**Grid Code Consultation – Improved planning code data exchange for compliance assessments B/07**

**Grid Code Consultation - B/07  
Improved Planning Code Data Exchange for Compliance Assessments**

Grid Code Consultation Paper B/07 Improved Planning Code Data Exchange for Compliance Assessments

## **GRID CODE CONSULTATION DOCUMENT B/07 IMPROVED PLANNING CODE DATA EXCHANGE FOR COMPLIANCE ASSESSMENTS**

**Diagram 1**

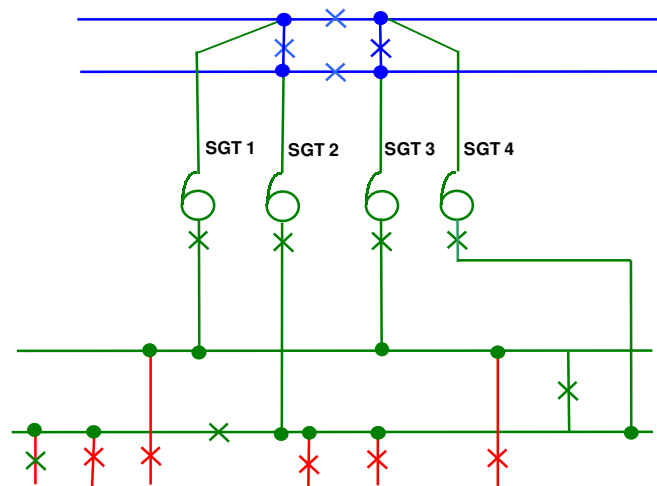
Ref	Section	Issue	Proposal
1	Definition	The definition of a Transmission Interface Circuit is only correct where the LV busbars are owned by a User. Where they are owned by NGET, the TIC includes the SGTs, LV circuit breakers and the LV busbars (see Diagram 1) – hence there is only one TIC	Revise the definition to add clarity
2	PCA 4.1.4.4 parag 2	The requirement should be for National Grid to submit the required information <i>by</i> week 6 rather than <i>in</i> week 6	Revise to read: For all other <b>Access Groups</b> , <b>NGET</b> shall be responsible for submitting the information in (a) and (b) above to the relevant <b>Users</b> <i>by</i> Week 6.
3	PCA 4.1.4.4 parag 2	There should not be a prescriptive requirement for NGET and relevant Users to physically meet to discuss the maintenance period submission. The requirement should be to jointly agree the maintenance period submission by week 17	Revise to read: Following the submission by the <b>User</b> or <b>NGET</b> in week 6 in each year and where required by either party, both <b>NGET</b> and the relevant <b>User(s)</b> shall use their reasonable endeavours <i>to agree</i> appropriate week 6 submissions prior to week 17 in each year.

**Appendix**

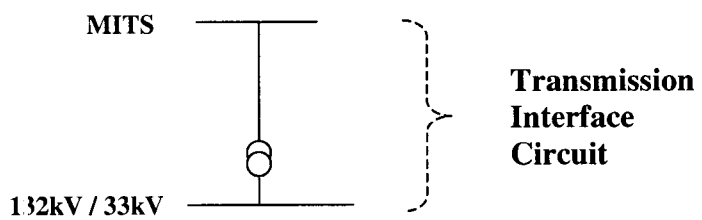
- More clarity is required on the definition of the TIC. The present definition is unclear and could be interpreted as covering either the infeed circuit, the infeed transformer only, or the entire circuit composition to the MITS. Given the objective of demonstrating maintainability of the Transmission Interface Circuits, we would propose that the definition of TIC must cover the full circuit from the connection point to the MITS (see the example in the appendix).
